Memorandum

RE: Change Order No. 2 Downtown Improvements Contract No. 2016-01

CHANGE ORDER

Contractor: Vinton Construction, Inc.
Contract No.: Unit No. 2016-01
Project: City of Menasha Downtown Street, Walkway and Electrical Improvements

MAIN STREET

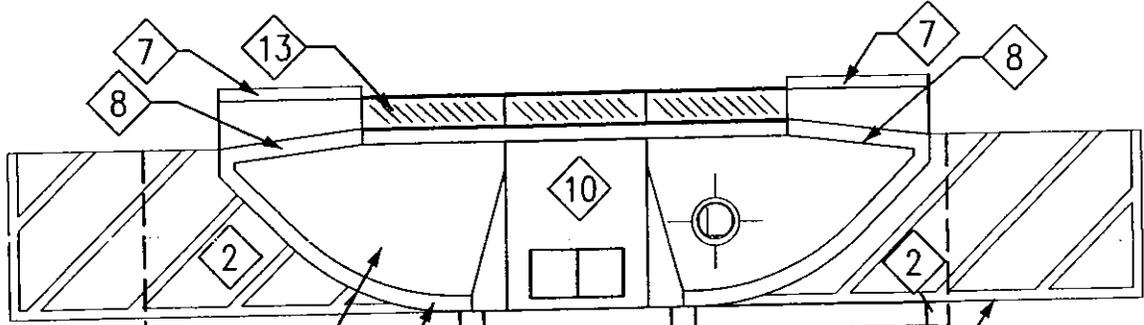
PROPOSED
ADDITIONAL
CONCRETE

MAIN ST.

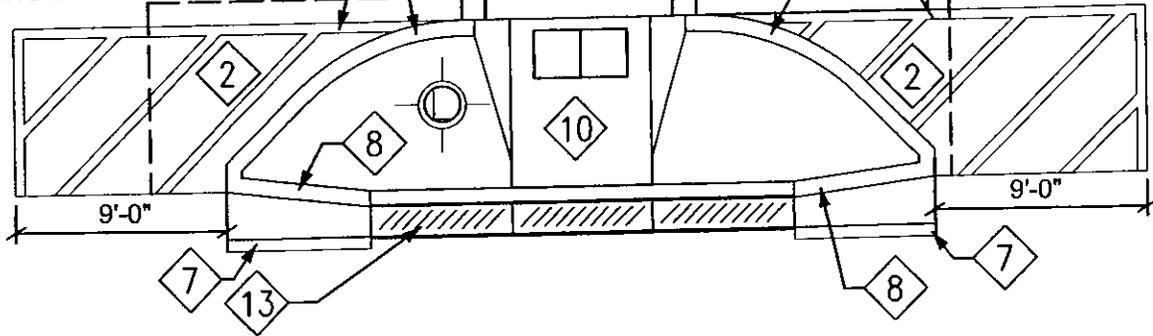
COLORED CROSSING

Broad Street Alley

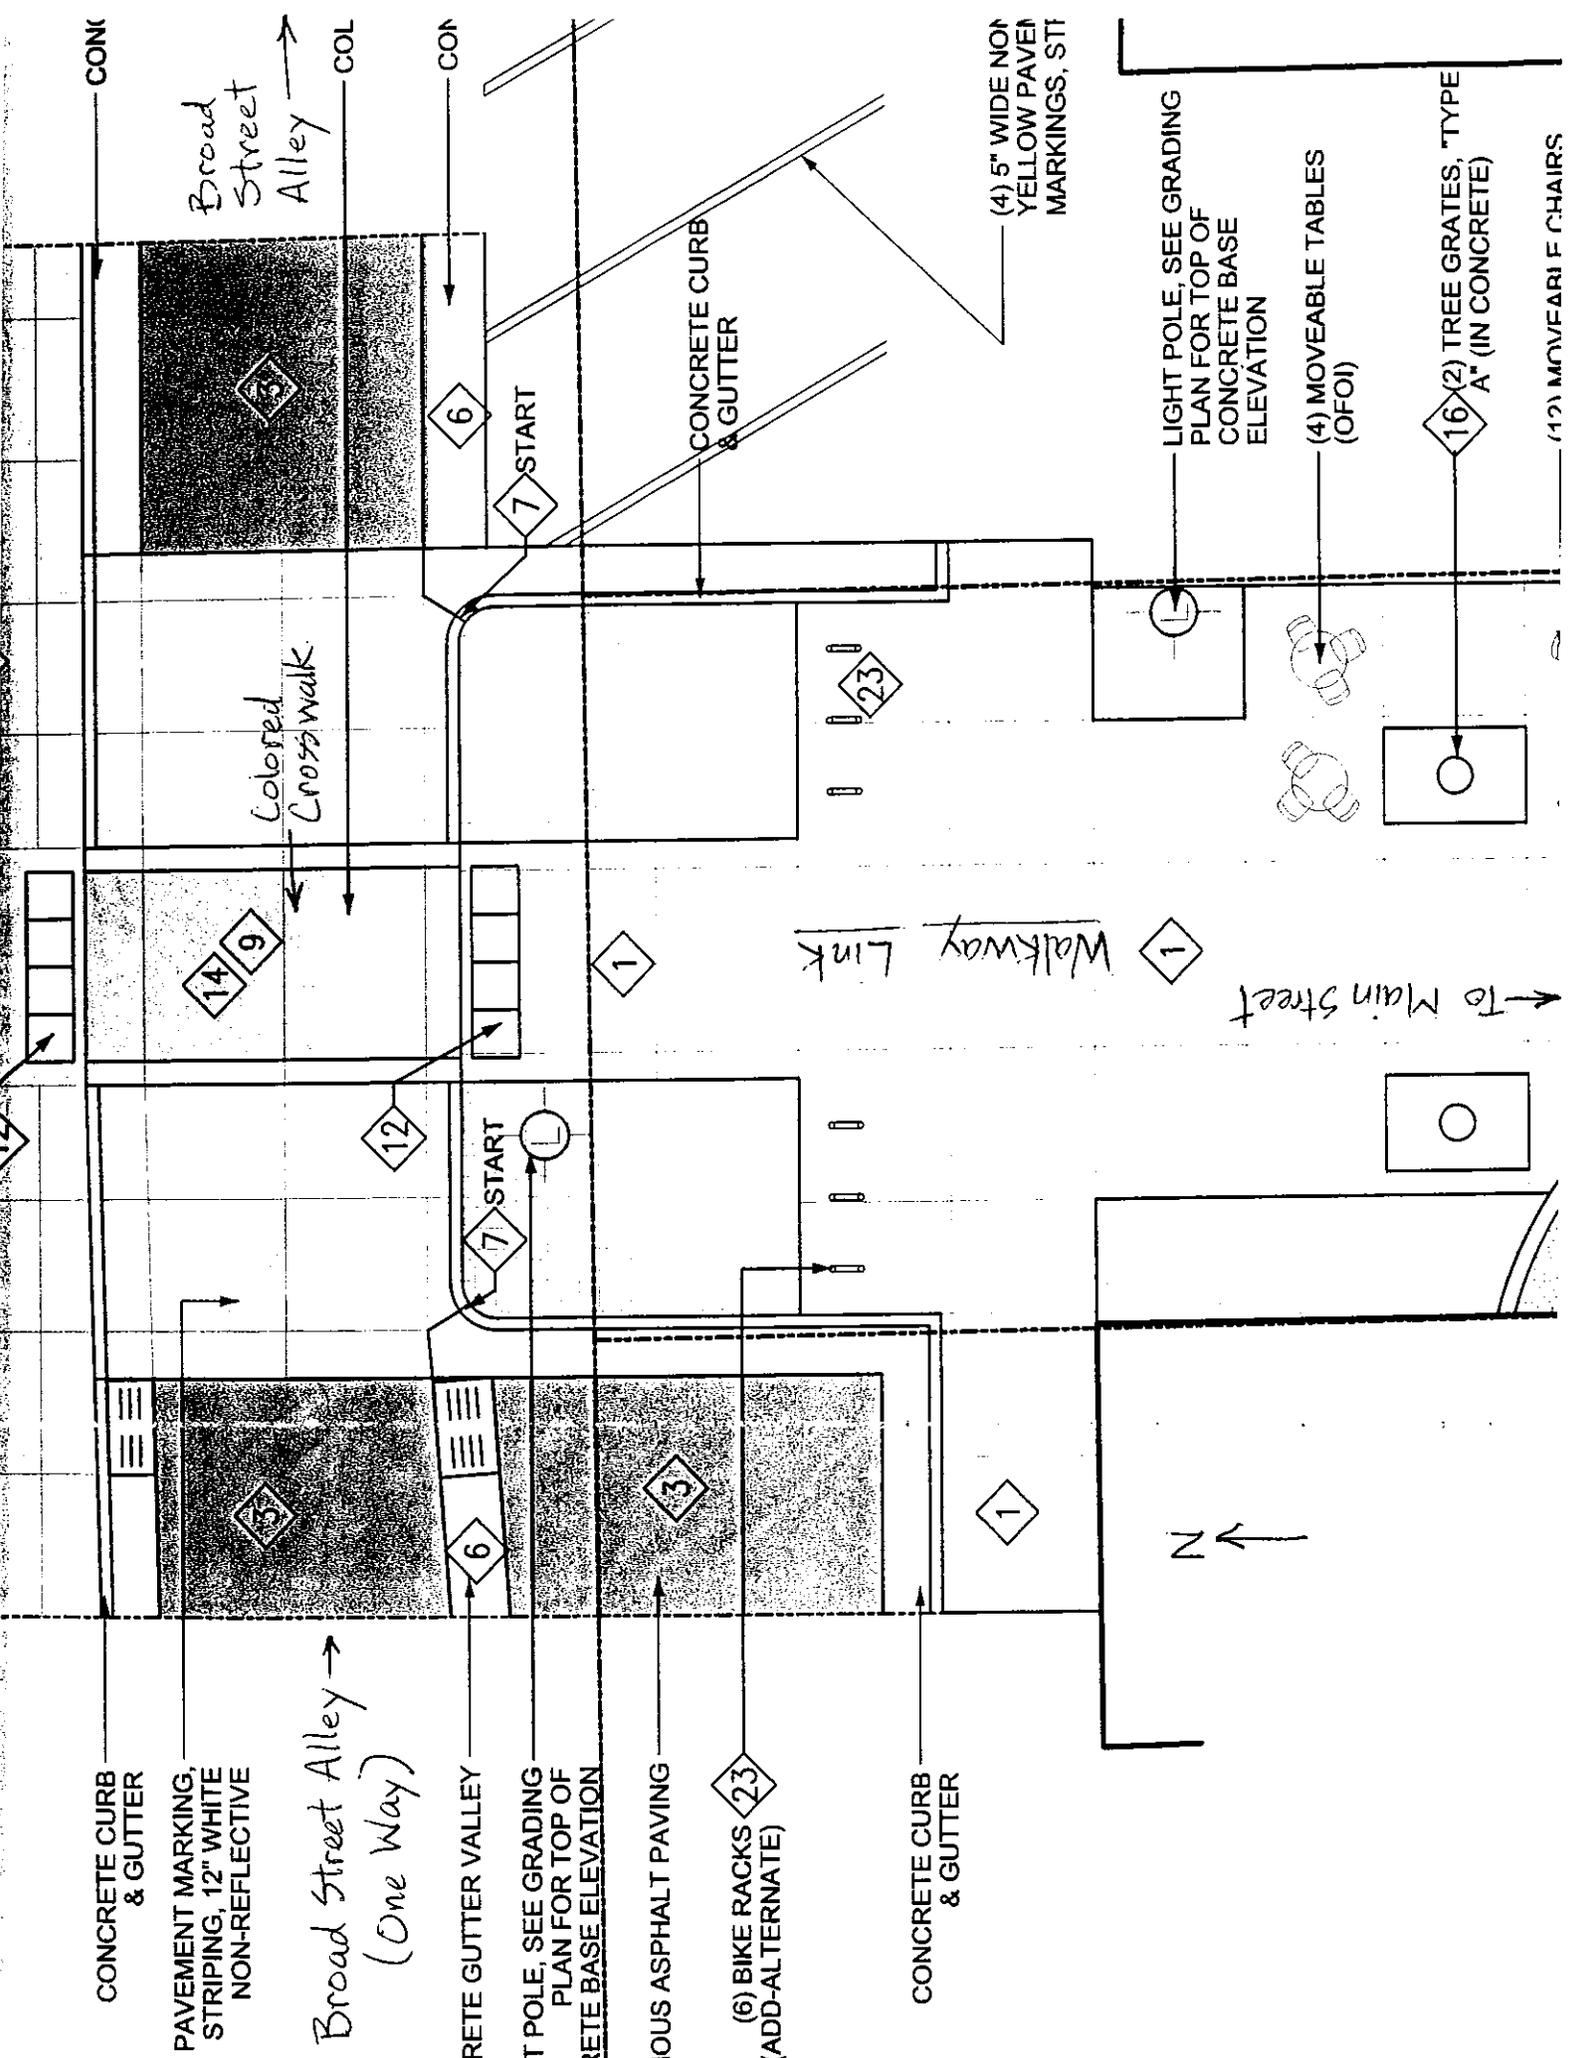
Colored Crosswalk
